UNITED STATES PATENT AND TRADEMARK OFFICE

APPLICATION NO.	FILING DATE	FIRST NAMED INVENTOR	ATTORNEY DOCKET NO.	CONFIRMATION NO.
10/807,420	03/23/2004	Craig A. Barrile-Josephson	P03137	3853
23702	7590	09/19/2007		
Bausch & Lomb Incorporated One Bausch & Lomb Place Rochester, NY 14604-2701			EXAMINER MENDOZA, MICHAEL G	
			ART UNIT	PAPER NUMBER
			3734	
			MAIL DATE	DELIVERY MODE
			09/19/2007	PAPER

Office Action Summary

DETAILED ACTION

FIG. 9

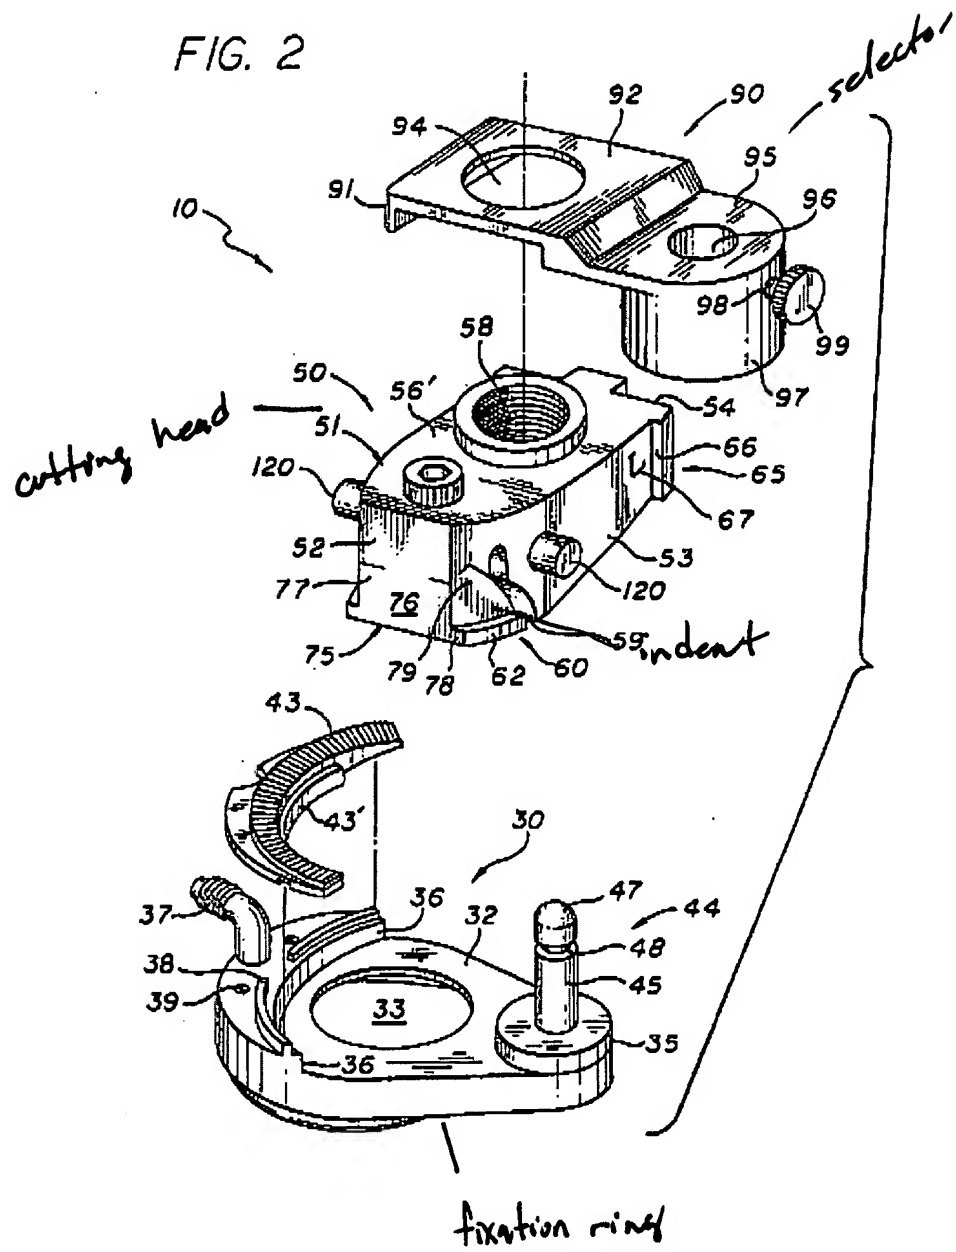
4. Claims 1, 2, 6, 7, 8, 10, 20, 21, 28, 29, and 31 are rejected under 35 U.S.C. 102(b) as being anticipated by Hellenkamp et al. 6051009.

5. Hellenkamp teaches a microkerotome for use in ophthalmic surgery comprising: a bar-link drive; a cutting head; a fixation ring; wherein the bar-link drive moves the cutting-head at least partially across the fixation ring; a controller; wherein the drive includes a left/right selector; a cutting-head locator; wherein the cutting-head includes indents on opposite sides of the cutting-head; wherein the fixation ring includes structure extending beyond a bottom-most part of an annular ring and raised about the bottom-most part of the annular ring; a motor 100; and a translation stop 65.
